UNITED STATES PATENT AND TRADEMARK OFFICE

APPLICATION NO.	FILING DATE	FIRST NAMED INVENTOR	ATTORNEY DOCKET NO.	CONFIRMATION NO.
10/560,472	12/12/2005	Jean-Louis Desjoyaux	1759-213	3145

Office Action Summary	Application No. 10/560,472	Applicant(s) DESJOYAUX ET AL.	
	Examiner Jessie Fonseca	Art Unit 3637

DETAILED ACTION

Fig. 5: Wison (US 5,590,493)

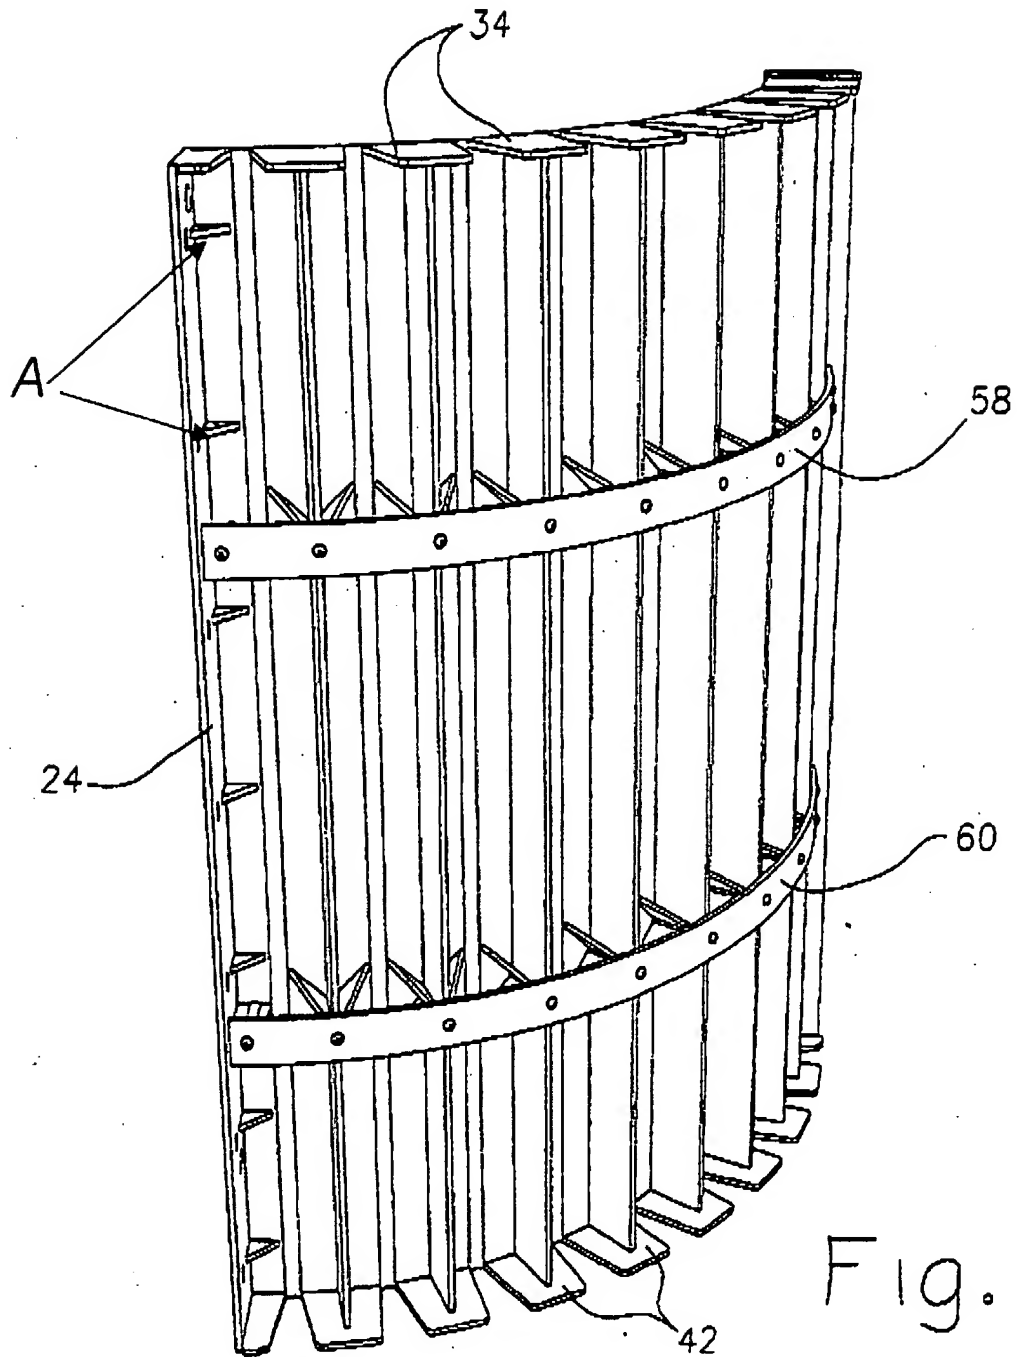
With regards to claim 7: Wilson, in view of Jerit and Laven, further disclose the outer face having catching and positioning arrangements (A) on the upper part (fig. 5). It is noted, that any part of the panel on the upper part serves as a catching and positioning arrangement as it can interact or couple with an attached item. The interacting with complementary arrangements of attached independent modifiable

With regards to claim 8:, Wilson, in view of Jerit and Laven, further disclose the outer face has, over all of it's height, catching and positioning arrangements (A) (fig. 5). The interacting with complementary arrangements of at least one attached independent element acting as a vertical shaft, in communication with the anchorage elements, for pouring of a concrete is related to an intended use and is given little patentable weight.

Fig. 2: Carling et al. (US 5,992,106)

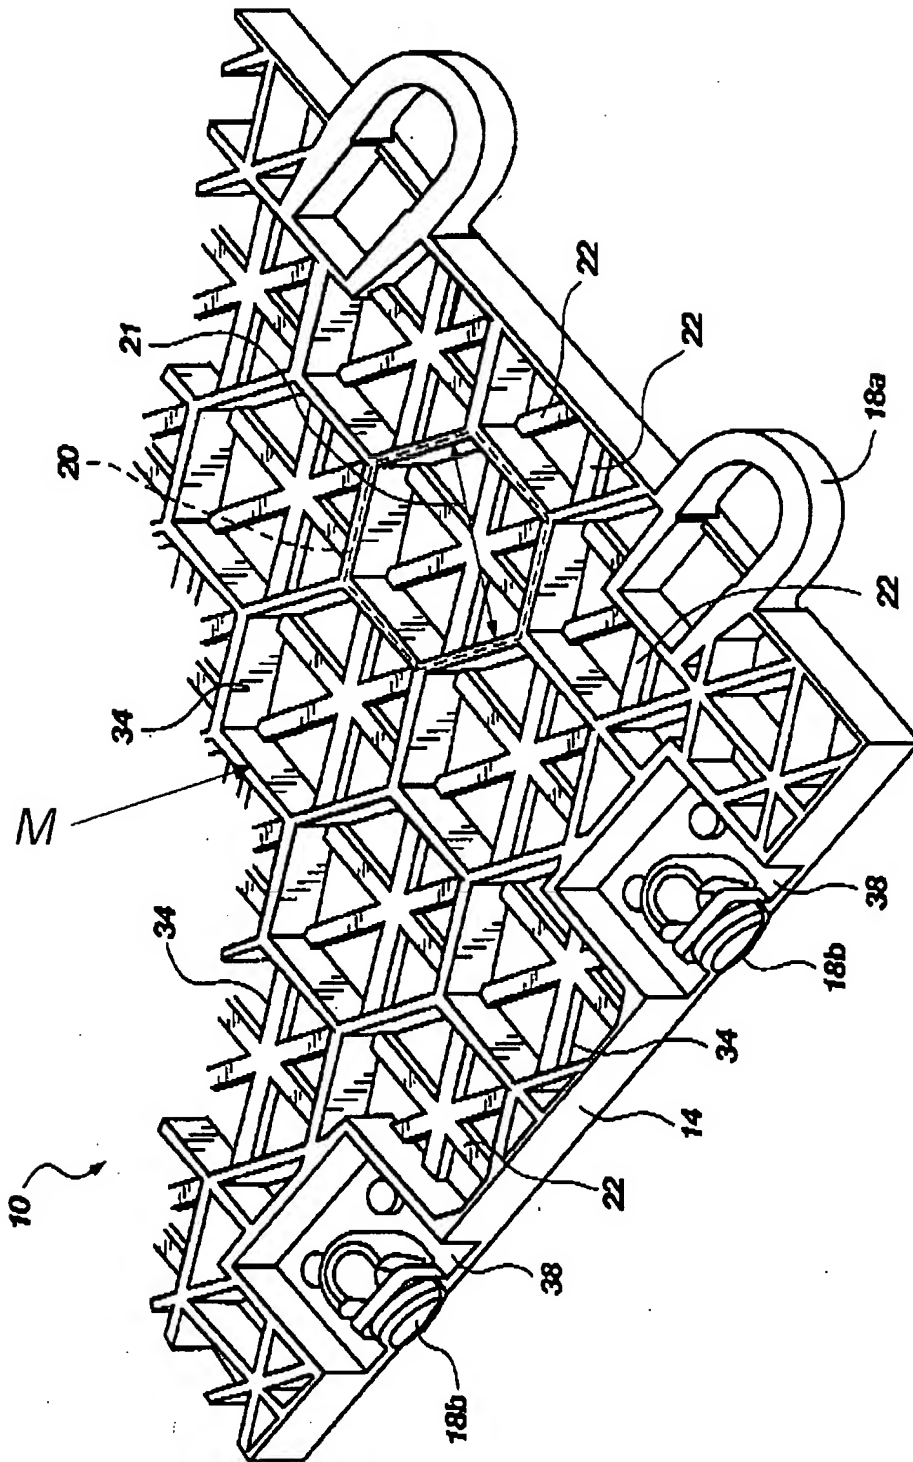
With regards to claim 9: Wilson, in view of Jerit and Laven, discloses everything previously mentioned expect the staggered fashion comprises a honeycomb. However, Carling et al. discloses a panel (10) having a plurality of ribs arranged in a staggered fashion in the form of honeycomb (M). Therefore, it would have been obvious to one of ordinary skill in the art at the time of invention was made to modify the panel of Wilson, in view of Jerit and Laven, to include staggered fashion comprising honeycomb as taught by Carling et al. in order to provide a configuration for increase structural stability and integrity of the panel.
